## DEPARTMENT OF TRANSPORTATION

#### 49 CFR Part 571

### Federal Motor Vehicle Safety Standards; Lamps, Reflective Devices, and Associated Equipment

**ACTION:** Final rule; response to petitions for reconsideration.

FIGURE 14

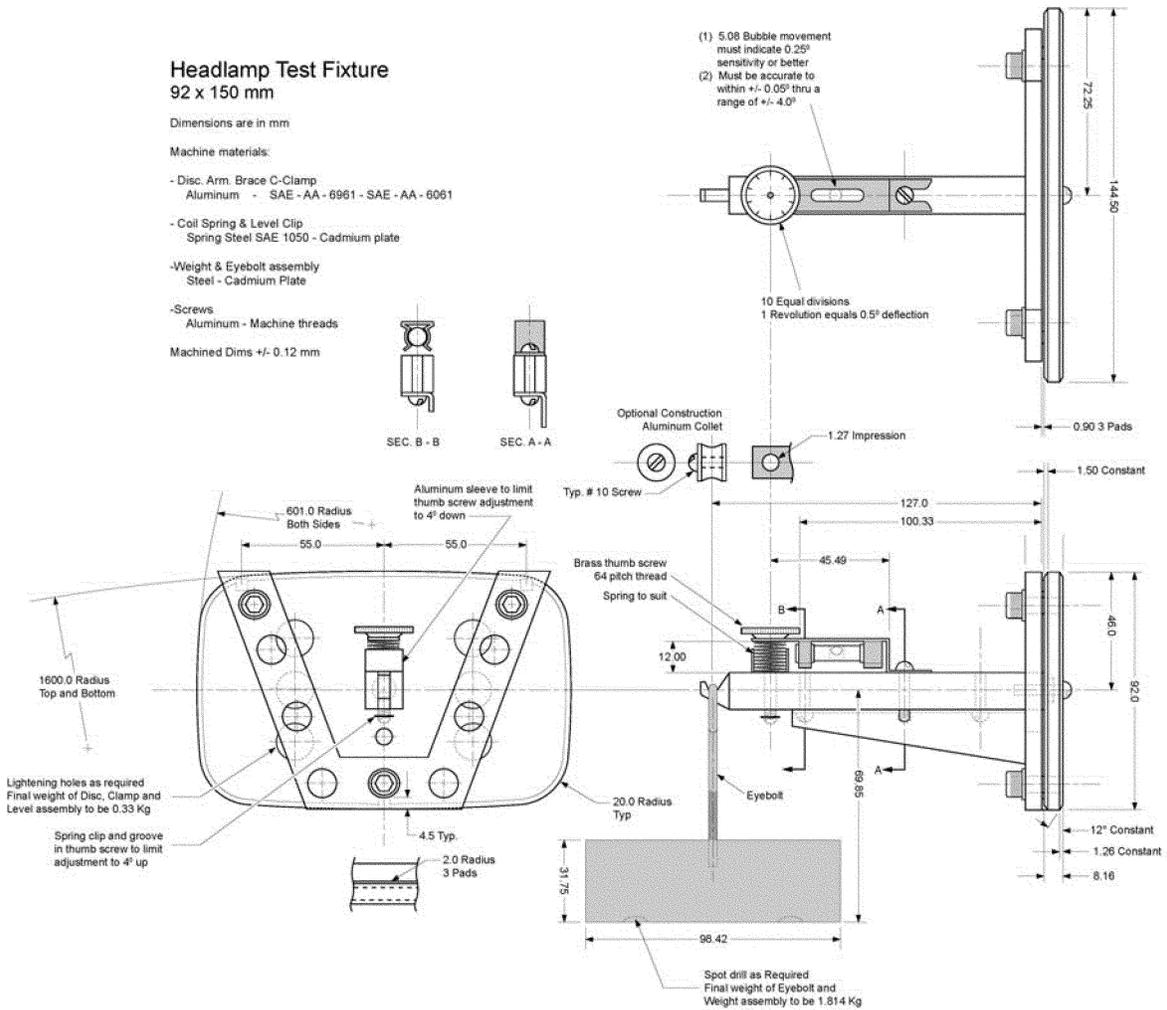
The Associations claimed that the final rule had an error in Figure 8, “Replaceable Light Source Detection Test Setup,” and requested that dimension “A” be replaced with the term “Light Center Length.” The Associations also requested that Figure 14 be changed. They stated that the material specification for the “Disc. arm Brace & Clamp” should appear as “SAE–AA–6061 T6 or equiv,” and the “Coil Spring and Level Clip” should appear as “Spring Steel SAE 1858 –Cadmium Plate.” Also, they stated that in Figure 14, “5.00 Bubble movement” should be replaced by “5.88 Bubble movement” and the screw “Typ. #18” should be “Typ. #10.” Finally, in Figure 14, the Associations suggested that the dimension of “100.33” should instead be “188.33.”

The Associations also requested changes to Figure 14 that include changing the “Disc. Arm and Brace Clamp” material from SAE-AA-6961 to SAE-AA-6061. The agency agrees that this was listed incorrectly and has modified Figure 14 accordingly. They also requested that the “Coil Spring and Level clip” material be changed to “Spring Steel SAE 1858—Cadmium Plate.” The agency does not agree as “Spring Steel SAE 1050” is called out in the currently applicable version of this standard. Therefore, we are denying this request. Also, the agency has corrected the value of the bubble movement to 5.08 and changed the screw number to “TYP #10” in Figure 14 because these changes are consistent with the currently applicable version of the standard. The dimension of 100.33 was correctly translated from the currently applicable version of the standard so the agency is denying the Associations’ request to amend that value to 188.33.
